Safety Evaluation Report

Renewal of the Facility Operating License for the University of Florida Training Reactor

License No. R-56
Docket No. 50-083

United States Nuclear Regulatory Commission

Figure 1-1 Illustration of Normal and High Plume Dilution System

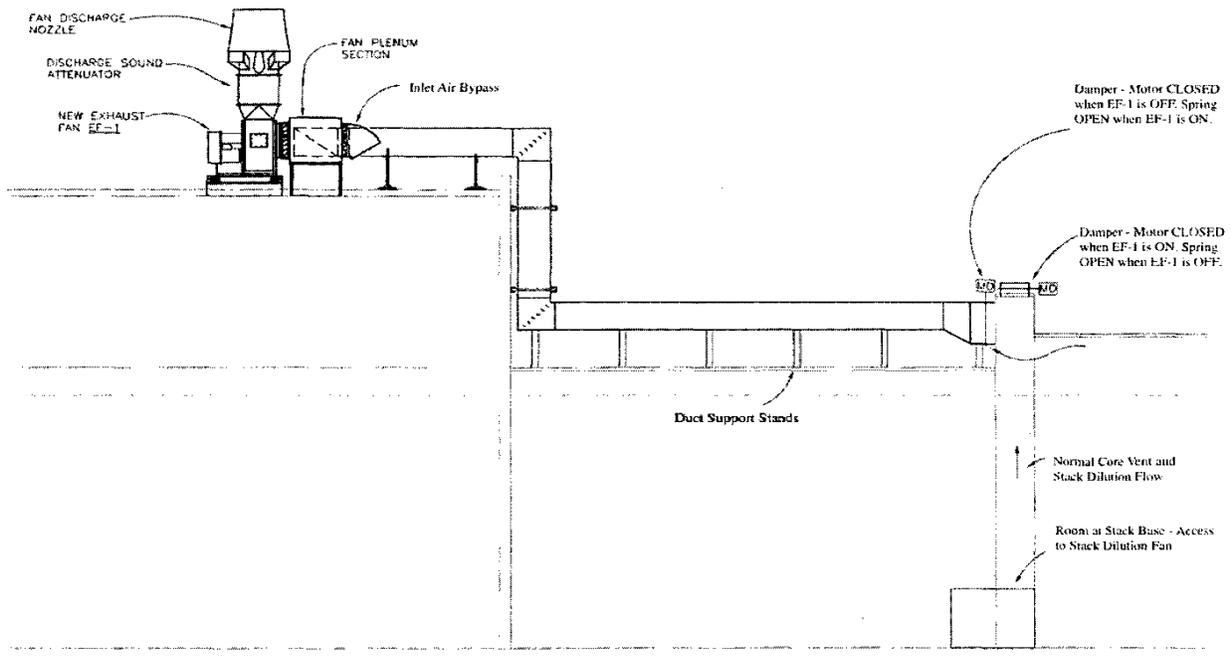
Section 9.1.3 of the UFTR SAR describes the stack dilution system. The system is stated to have two modes of operation. In normal mode, the existing, previously-approved system exhaust exits the roof vent through the normally open damper. The UFTR high plume ventilation system is shown in the SAR as Figure 9-3 and reproduced in Figure 1-1 below.

For purposes of the licensee's calculations, the normal mode of operation is analyzed to support the Ar-41 and accident dose calculations as described in Chapters 5 and 6 of this SER. In the submitted SAR and RAI responses, the high plume system operating characteristics are not described and the licensee conservatively does not credit the operation of the high plume system. The system is described in the licensee's 10 CFR 50.59 review documentation.

Figure 2-8 22-Assembly BOL Power Distribution at 110 kWt

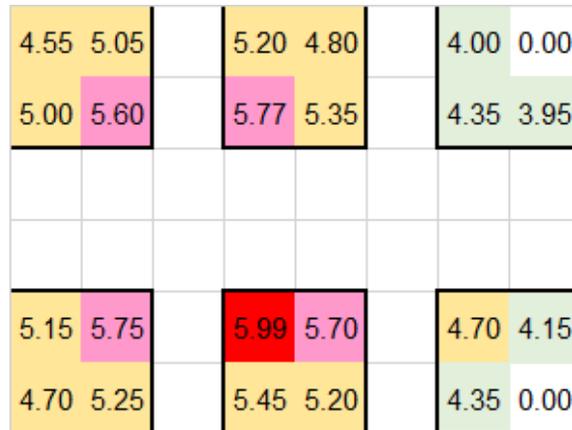
Using the same peaking factors, the power at 110 kWt is then shown in Figure 2-8.

Figure 2-9 Confirmatory T&H Model

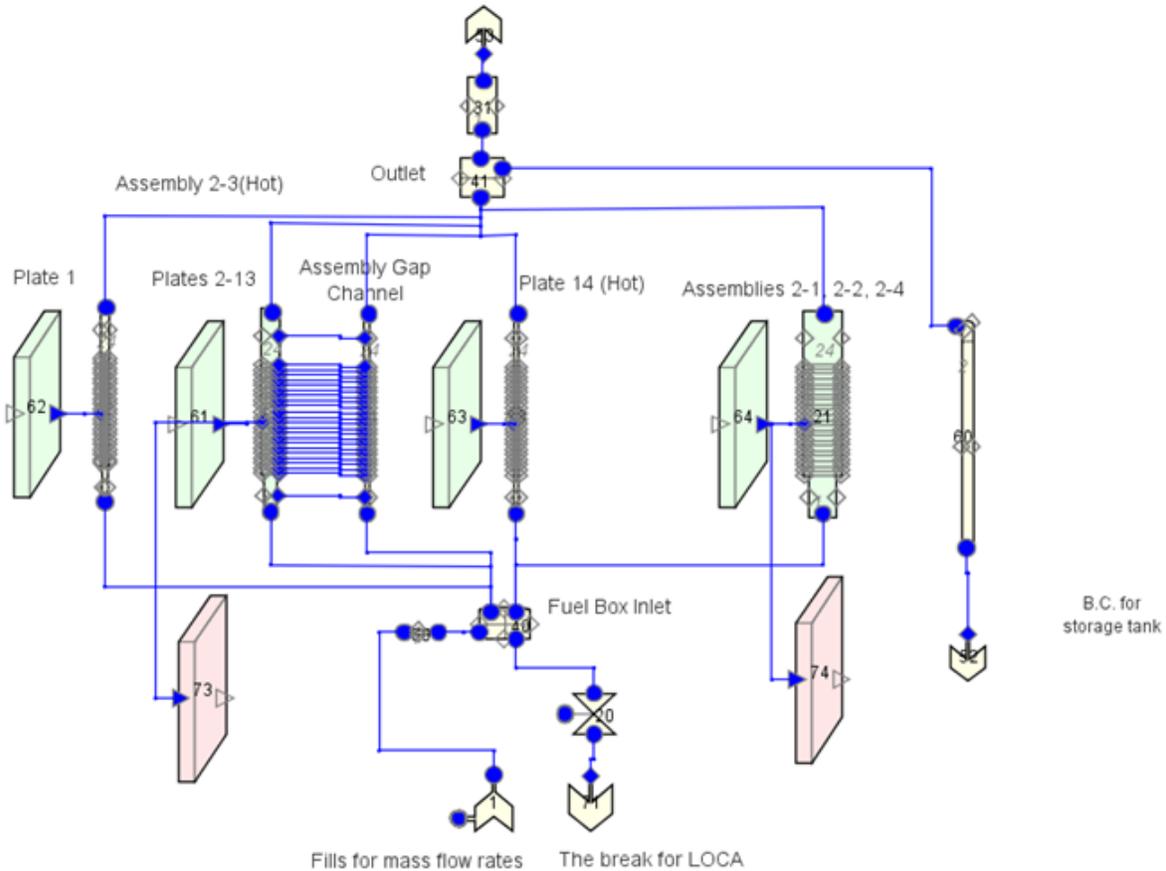
The NRC staff performed a confirmatory analysis using the TRAC/RELAP Advanced Computational Engine (TRACE) computer code. The model of the UFTR is shown in Figure 2-9. In this model the limiting fuel box is modeled as five regions:

The NRC staff performed a confirmatory calculation to verify the results of the licensee's LOCA analysis. The NRC staff analyzed this event using the TRACE model shown in Figure 2-9 in SER Section 2.7. In this simulation, the break size is 1/6 of the flow area of the dump valve (3 inches), since the TRACE model considers only one of the six fuel boxes as the hot fuel box. The simulation runs for 100 seconds at full power to establish the steady state conditions. The decay heat generated by the core is based on the SAR analysis. At 100 seconds, the pump shuts off, the dump valve fully opens, and the vacuum breaker opens, allowing water flow through the dump valve and air entry into the reactor. The reactor is assumed to scram, with the rods inserting during the 2 seconds following the opening of the dump valve. The NRC staff

Figure 3-1 UFTR Primary Coolant System

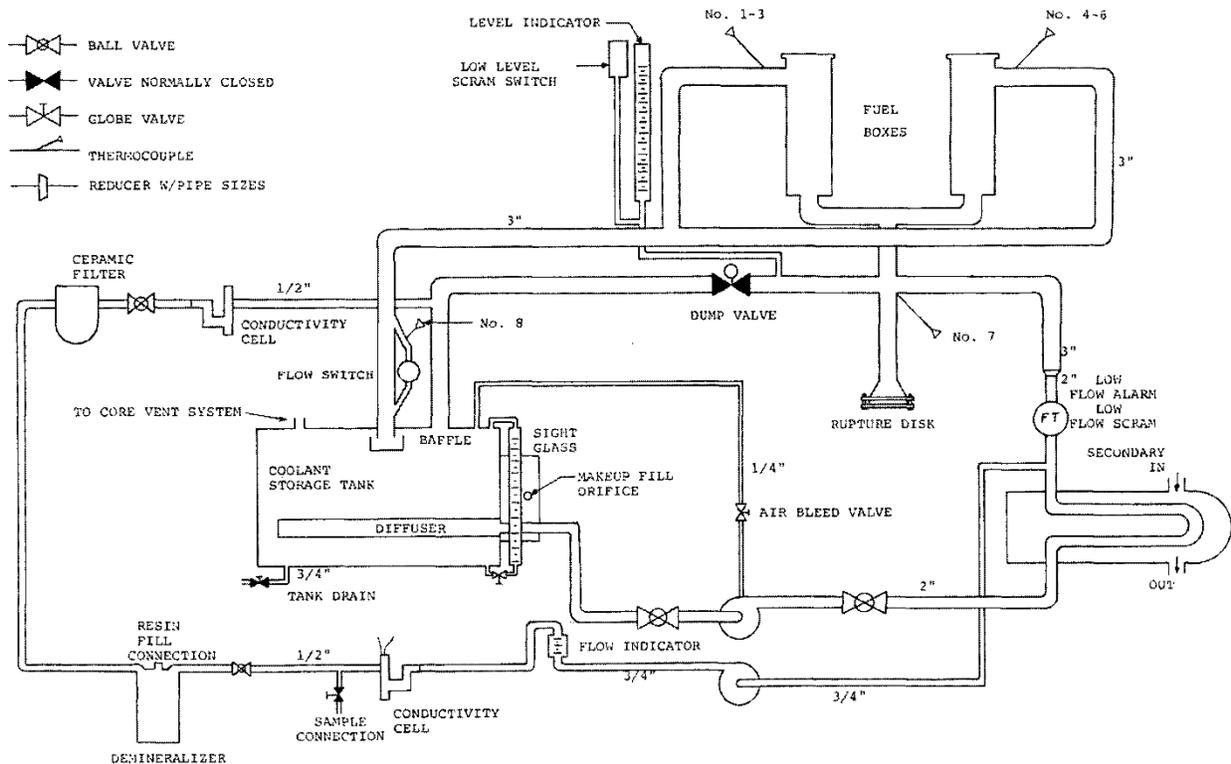
The UFTR primary coolant system is shown in Figure 3-1 (reproduced from SAR Figure 5-1). The demineralized primary water is stored in a 200-gallon coolant storage tank, which is approximately six times larger than the 33-gallon capacity of the reactor core boxes. A temporary hose connection is used to provide makeup water through an orifice located on the storage tank. Before entering the storage tank, city water passes through two demineralizers in series to remove any contaminants. The primary coolant is drawn from the storage tank by the primary coolant pump and circulated near atmospheric pressure at a flow rate of approximately 46 to 48 gallons per minute (gpm) limited by a ball valve in the pump discharge line. The coolant flows through the heat exchanger before being delivered to the six fuel boxes that make up the reactor core. Water flows up and around the fuel, rising to the top of the fuel boxes, where it is discharged through orifices located on the sides of the fuel boxes. Coolant from the six fuel box side orifices is then piped by gravity back into the coolant storage tank.

TS 5.2.2 establishes the requirement for a rupture disc designed to break at approximately 2 psi above normal operating system pressure, and cause water from the core to be drained into the equipment storage pit. The NRC staff reviewed the rupture disc configuration during site visits and finds that the rupture disc configuration is consistent with the description the SAR and SER Figure 3-1 above. The NRC staff also finds that the rupture disc supports assumptions used in the loss of coolant accident (LOCA) analysis, SER Section 6.3.

Figure 6-1 LOCA Water Level in the Fuel Box

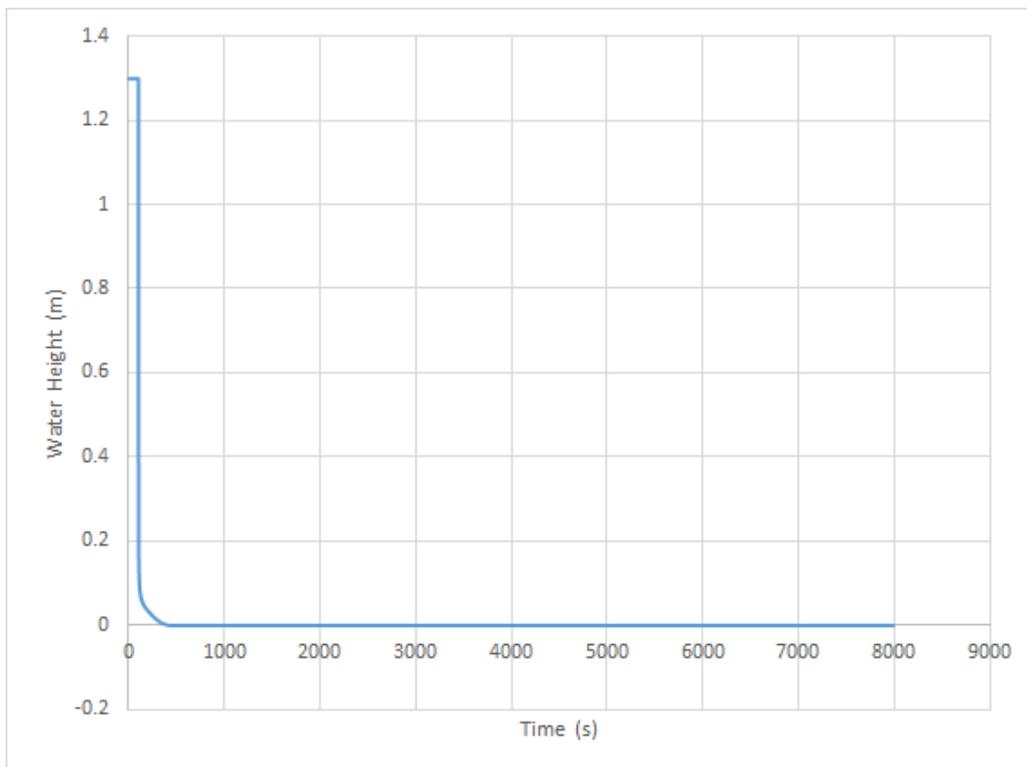
In its response to RAI 7.b (Ref. 24), the licensee stated that the time to drain the core following opening of the dump valve is approximately 12 seconds. The NRC staff finds that this drain time is a reasonable assumption for any LOCA event, given the core geometry. In confirmatory calculations, the NRC staff assumed that after the valve opens, the water drains in 12 seconds, at atmospheric conditions. Heat structures are used to model the heat transfer to the graphite moderator elements surrounding the fuel boxes, since these elements absorb some of the decay heat. The highest fuel and cladding temperature predicted by the TRACE is 139 °C, near the bottom of the fuel plate. As the scenario continues, the water drains through the dump valve and water drain line, while the same volume of air comes into the fuel boxes through the vacuum breaker vent lines connected at the top of the fuel boxes.

The water level in the core and the fuel-cladding temperature at the top and bottom of the fuel, as a function of time, are shown in Figure 6-1 and Figure 6-2. As Figure 6-2 indicates, the fuel temperature rises to about 140 °C. This is well below the 530 °C SL for the UFTR. Therefore, the NRC staff finds that the temperature rise associated with either a LOCA event, or a full scram that includes a water dump, is controlled by air cooling of the fuel. The analyses show that the peak fuel temperature will not exceed the SL.

Figure 6-2 LOCA Fuel Temperature Behavior

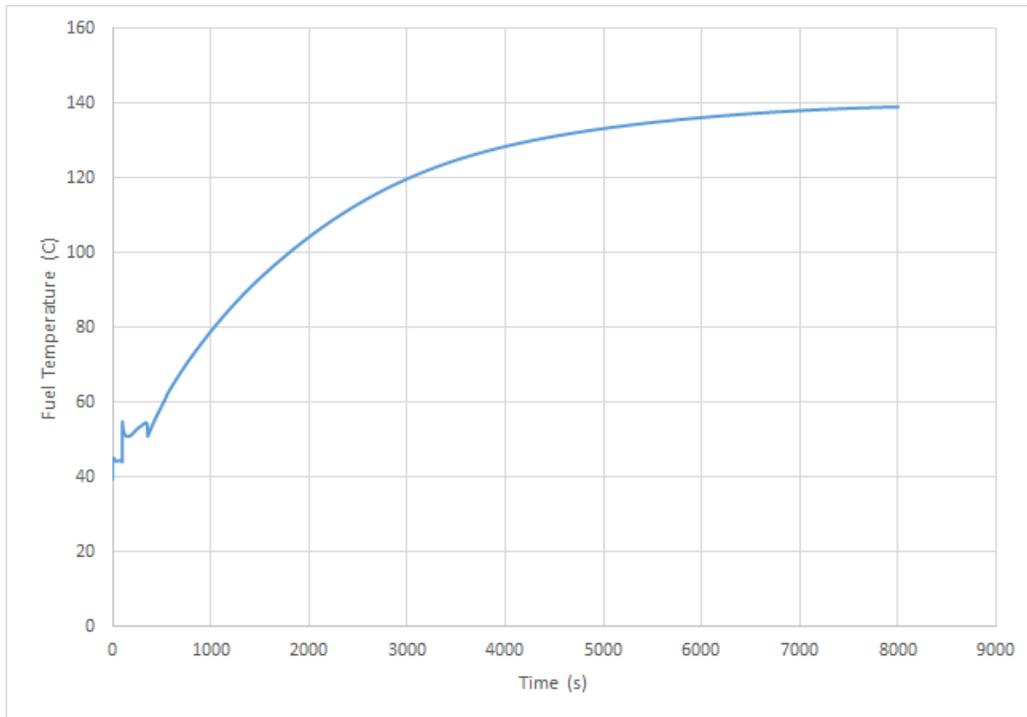
The NRC staff reviewed the information provided by the licensee, and also performed confirmatory calculations, as discussed above, to verify the licensee’s analysis. The NRC staff finds that the licensee and NRC analyses demonstrate that if a LOCA were to occur, it would not result in damage to the cladding or the fuel. Therefore, based on the information above, the NRC staff concludes that the results of the LOCA analyses are acceptable.

TS Figure 6-1 UFTR Organizational Chart

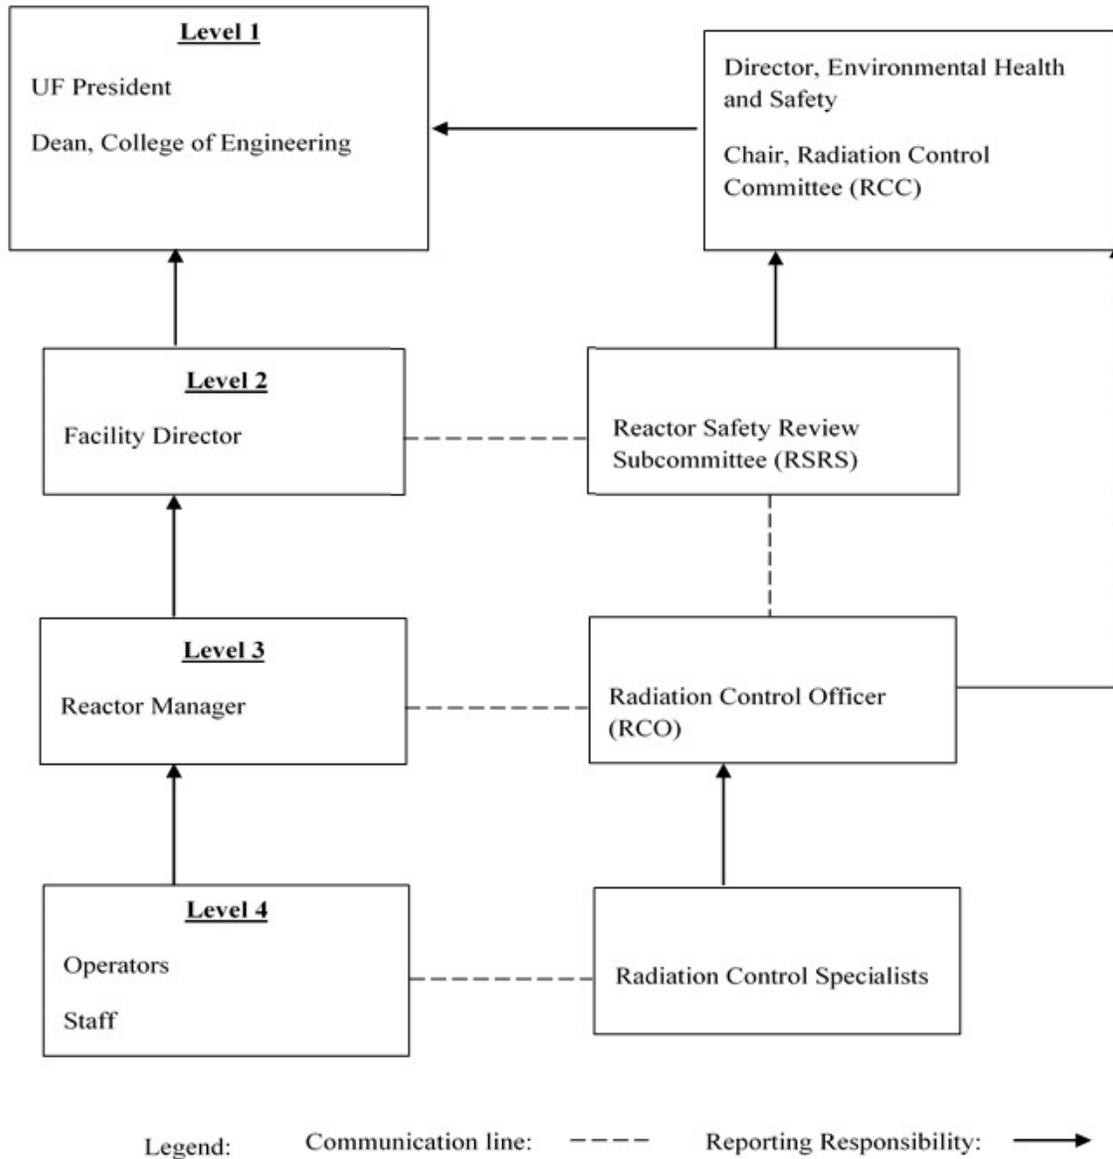
TS 6.1.1 requires the UFTR organization structure to be organized as shown in TS Figure 6.1. The NRC staff finds this specification helps ensure that the UFTR organization structure, including the communication and reporting lines, are properly delineated by the TSs. The NRC staff finds that the UFTR organizational structure in TS Figure 6.1 is consistent with the guidance in NUREG-1537 and ANSI/ANS-15.1-2007. Based on the information provided, the NRC staff concludes that TS 6.1.1 and TS Figure 6.1 are acceptable.

TS 6.1.2 provides the positions at UFTR responsible for safeguarding the public and facility personnel from undue radiation exposure and implementing the TSs. The NRC staff finds that this specification helps to ensure that key positions in the UFTR organizational structure understand their TS responsibilities to meet the conditions of the license and regulations. The NRC staff finds that the organizational responsibilities described in TS 6.1.2 are consistent with the guidance in NUREG-1537 and ANSI/ANS-15.1-2007. Based on the information provided, the NRC staff concludes that TS 6.1.2 is acceptable.
